# **TP2/TP3 Progress: Comments and Suggested Areas for Consensus**

Lew Aronson – Finisar

September 27, 2004

# Popescu/Dawe Static Test ISI

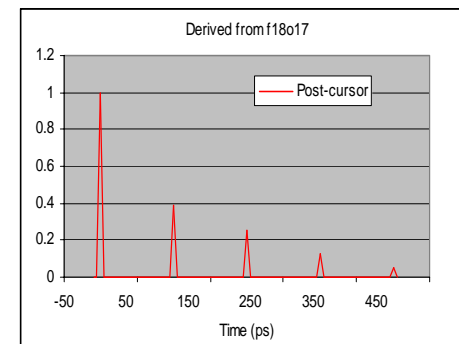
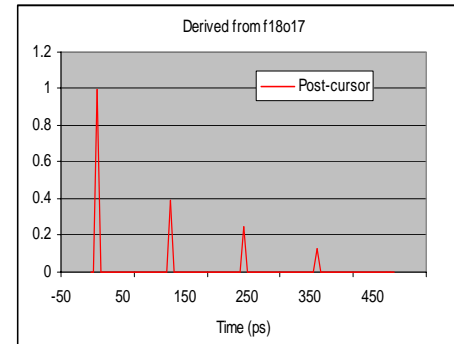
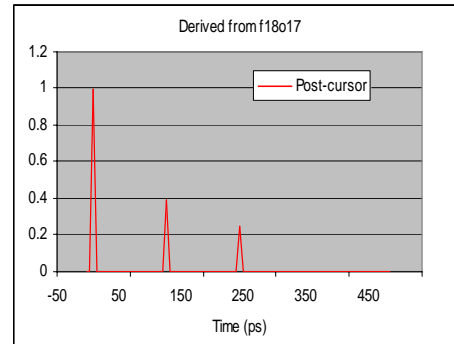
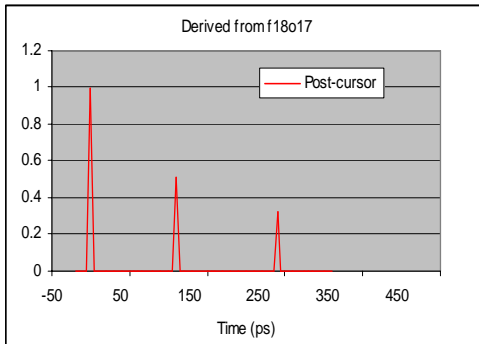
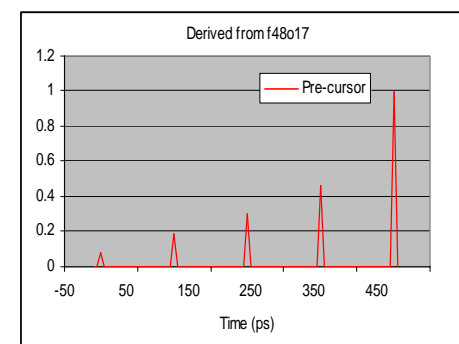
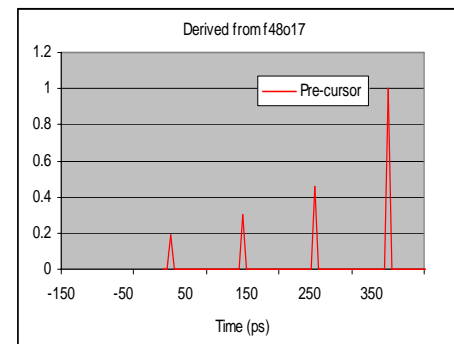
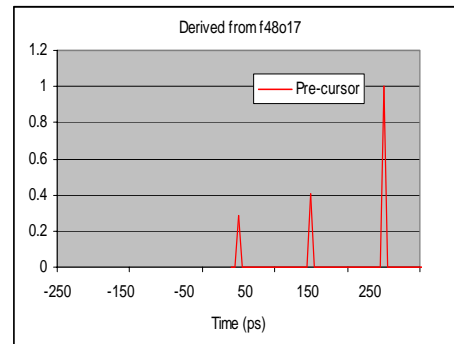
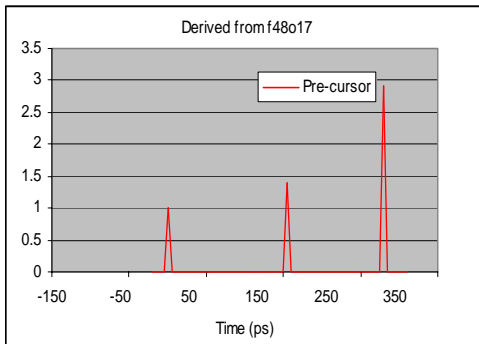
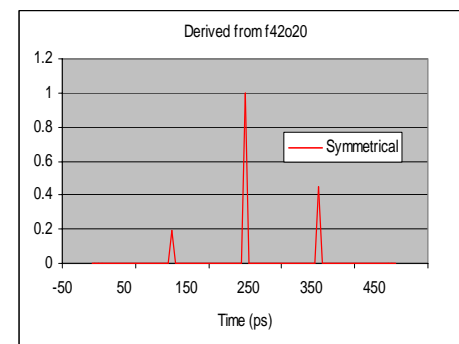
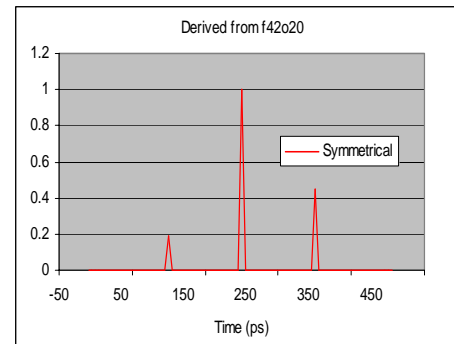
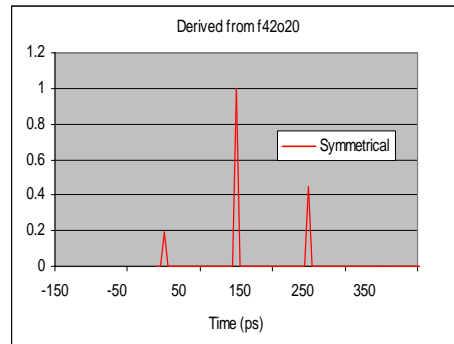
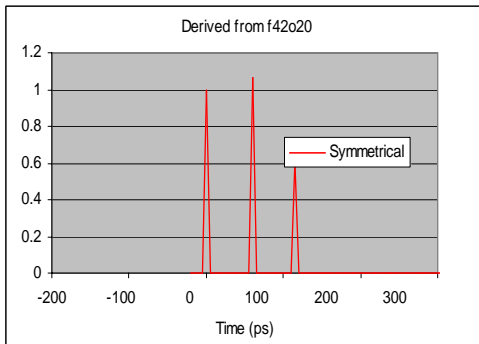
- Is Fixed  $\Delta T$  of 1 UI Dangerous?
  - Will Coincidence with Likely EDC Tap Spacing Result in Overly Poor or Good Performance
- Use of 30 ps Rise/Fall in Model of TX Pulse Shape

- Puts Tight Requirement on Test Source E-O Converter and Passive Connections
  - Example:
    - DM FP Laser as E-O May be Best for Spectral Reasons but 30 ps May Be Difficult.

- FP Source + Modulator Good but 1310 Modulators More Difficult to come by.
  - Can We Get Reasonable Alignment with Slower Source (say 47 ps r/f)?
- Exact Match of Specific Fibers Probably Not Critical

- Flexibility Would Allow Symmetric Post-Cursor and Pre-Cursor Tests
  - Would Justify Fixed  $\Delta T$  Models with Otherwise Poorer Fits to Specific Fibers

- Ultimately Turns Into Debate onto How to Write Test:
    - Method 1: Mimic these 3 Fiber Impulses as Well as Possible – Requires Describing Pulses (I.e. a detailed Table), **Will Look Mysterious Without History and Does Not Suggest Implementation**

- Method 2: Use 4 (or 3 or 5) Peak ISI Generator (I.e. **Prescribe the Generator**)
    - Method 3: Use 3 or 4 or 5 Peaks as a Language of Defining the ISI, But Specify It Must Be Met To A Certain Accuracy (Petre's PSR metric for example) – **Allows Freedom But Suggests Implementation**

# Discussions on RIN/Modal Noise Interferer

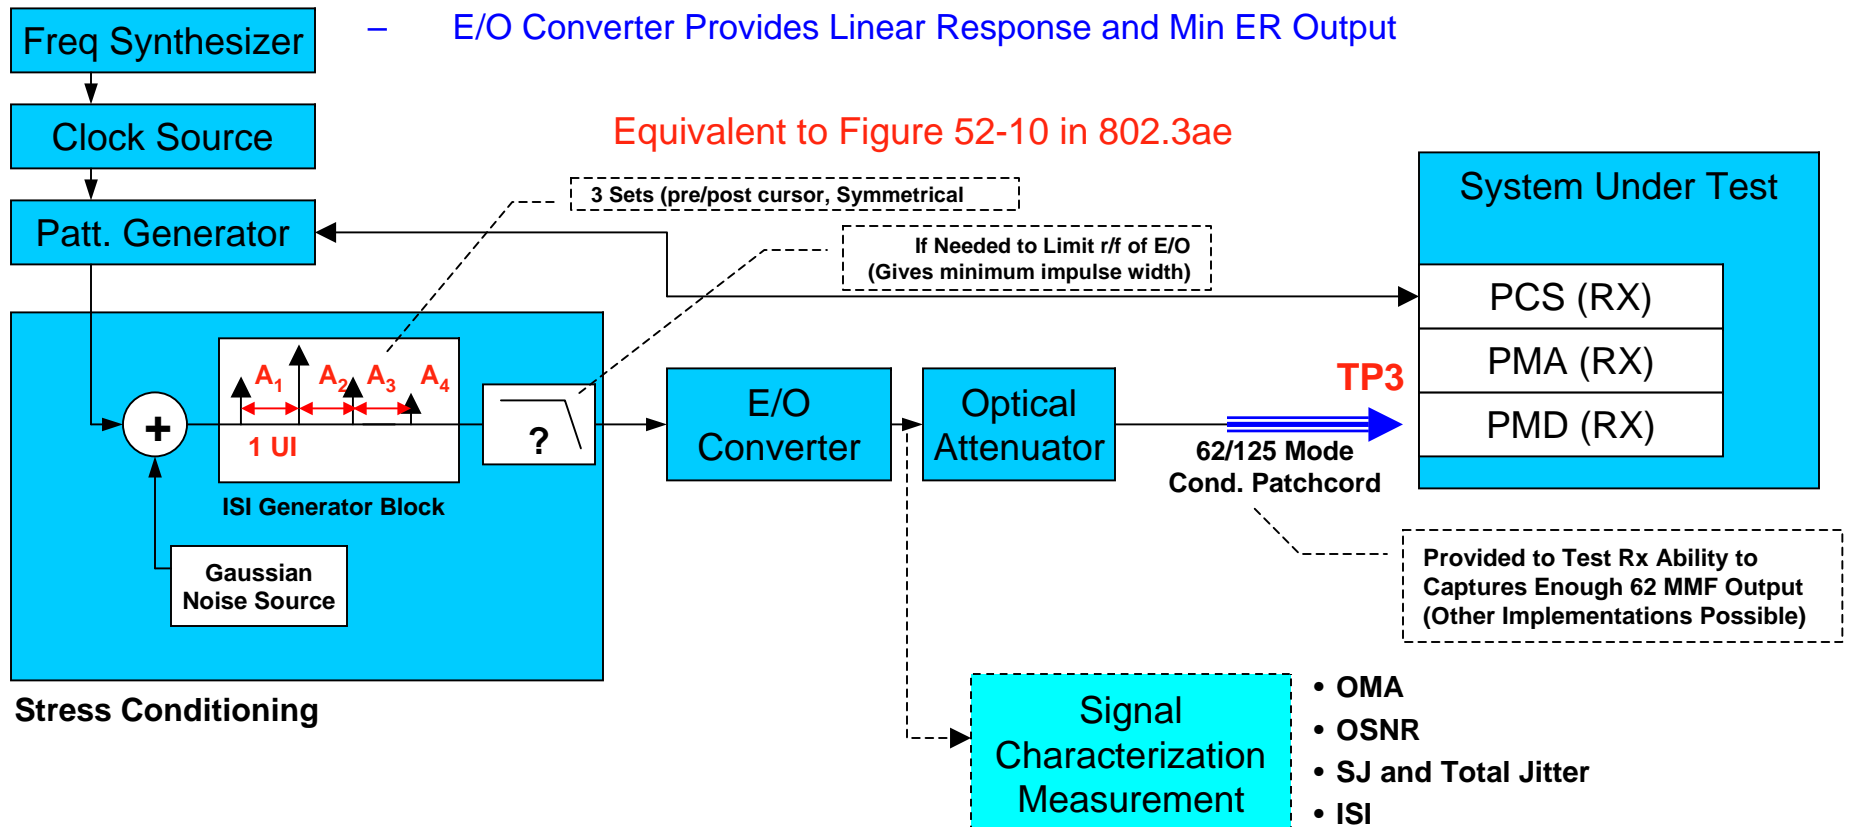
- **Original Proposal**
  - Simulate Combined Effects of 0.4 dB RIN and 0.5 dB High Freq Modal Noise Penalties Using Sinusoidal Interferer
  - Motivated Only by 802.3ae Interferer and Desire to Retain Hardware.

- (why was that sinusoidal?)
- **Comments Which Followed**
  - RIN is Certainly Opposite of Sinusoidal Interferer.
    - Well Approximated by Broadband (White) Gaussian Amplitude Noise

- Modal Noise is Probably More Complex But Sinusoid Probably Bad Approximation
- **Proposals Which Followed**
  - Used PRBS as Broader Source
  - Use White Gaussian Noise Source of > 10 GHz Min Bandwidth

- **Conclusion:**
  - Gaussian Noise Addition is Practical.
    - Good Simulation of RIN
    - If Not Good Simulation for Modal Noise, Probably Errs on High Side as EDC Stressor

- Use Gaussian Noise to Generate 0.9 dB Penalty Which at Worst Will Err a Bit on High Side
  - Add Gaussian Noise to Signal so Total of Original, Gaussian Noise  $\equiv$  0.9 dB Penalty

- Might Break Down if Modal Noise Much Worse. Adopt it Until Then.

# Dynamic Test ISI Considerations

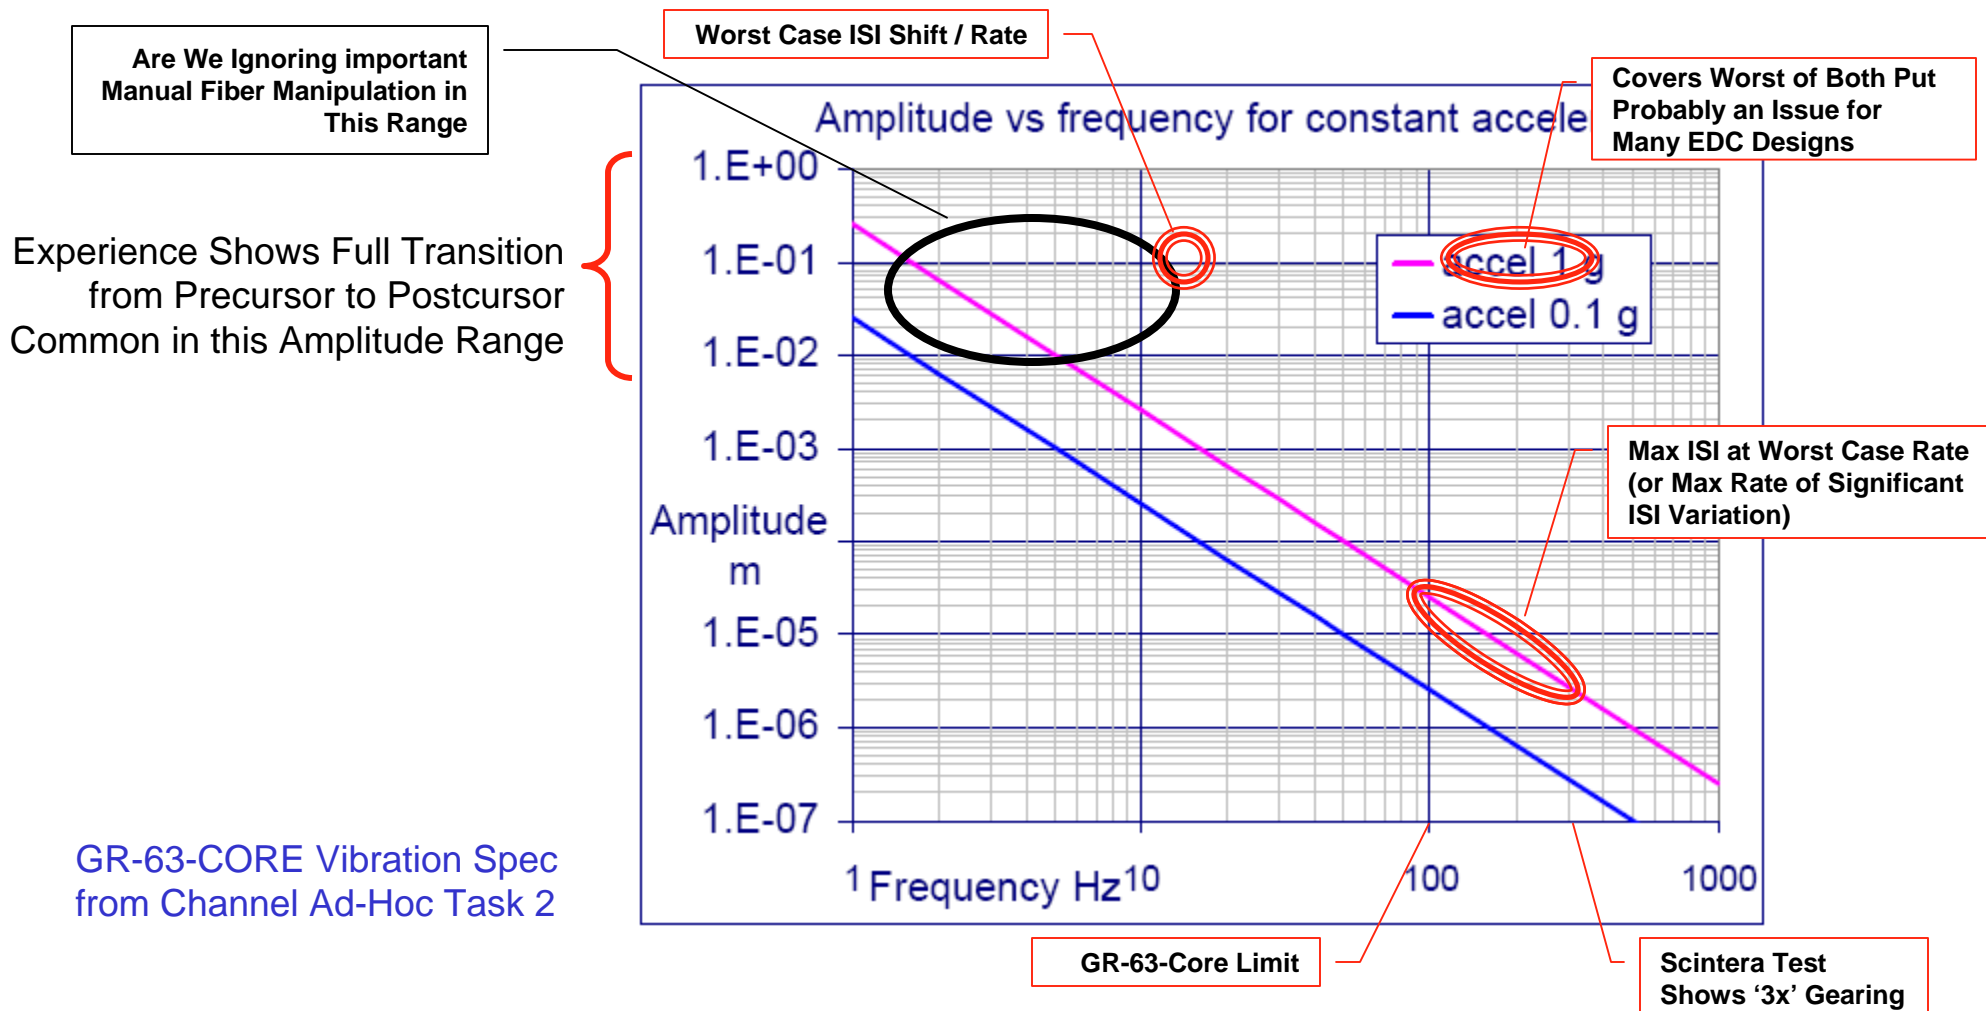
- Look at Two Limits:
  - Max Rate of Worst ISI Changes (full pre-cursor to post-cursor)
  - Max ISI Changes at Worst Case Rate (or max rate of significant ISI shifts)

# OMA Measurement Discussion

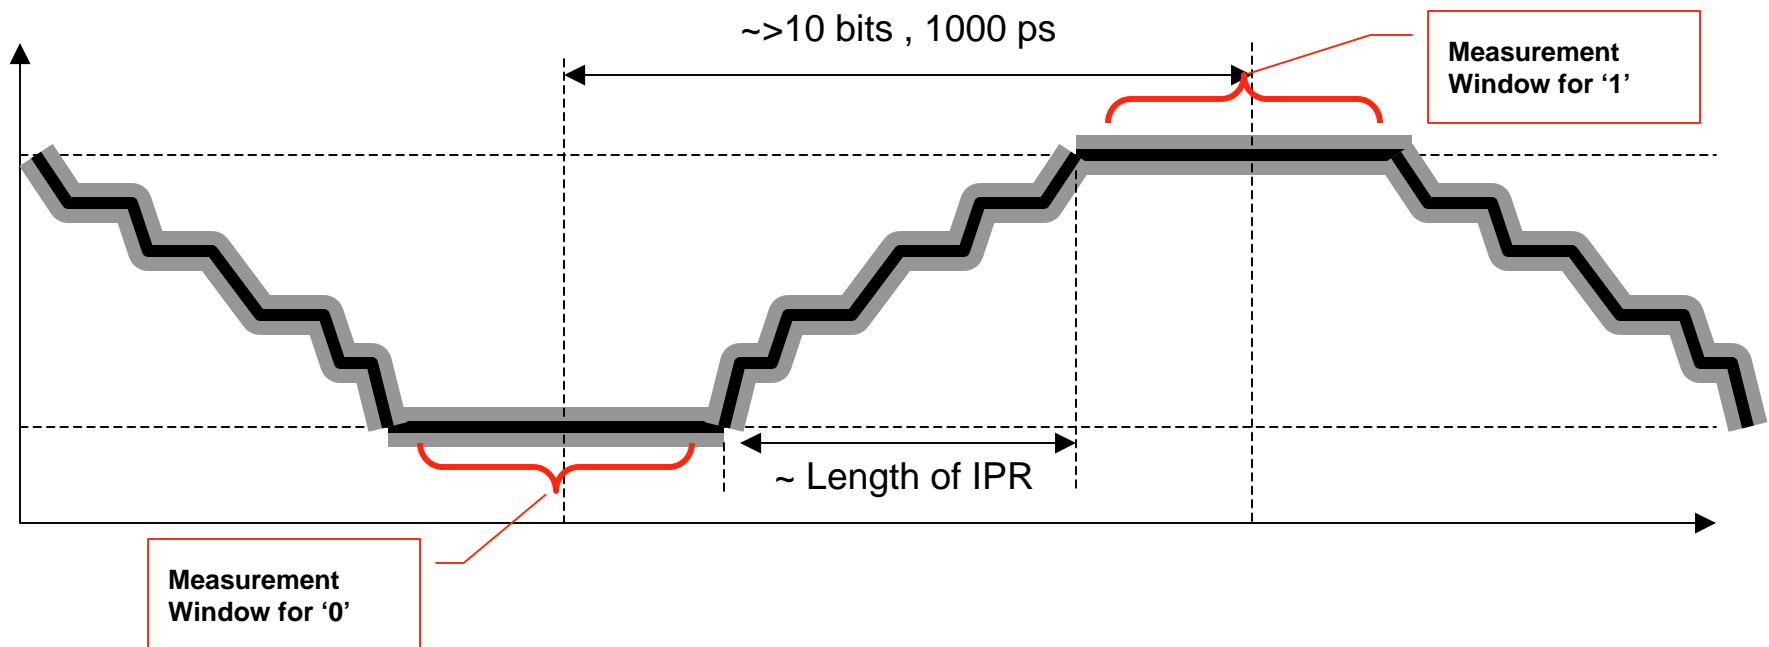
- **OMA Measurement Definition Required for Basic TX and RX Specs as Well as TP2 and TP3 Tests**
  - TP2 OMA Measurement Should Be Able To Use 802.3ae Definition Unless TP2 Compliance Test Allows Very Non-Standard Transmit Signal (New Transmit Penalty test, Abandoned Eye Mask etc)
  - TP3 Compliance Signal Calibration and Measurement of Received Signal of Real Links is More Complex
- **Recommend Square Wave Test Pattern Method Similar to 802.3ae Clause 52.9.5**
  - A Square Wave Test Pattern of Length Longer (at least 1.5x) than IPR Duration + Rise/Fall of TX/RX Ref Receiver Allows Clear Isolation of 0 and 1 Levels as in 802.3ae OMA test
  - For TP2, Want to Test Out of System, and 4 Bits Good Enough
  - For TP3 Signal Conformance, Just Use Longer Square Wave (Suggest >1.5x Final Stressed Test IPR Length)
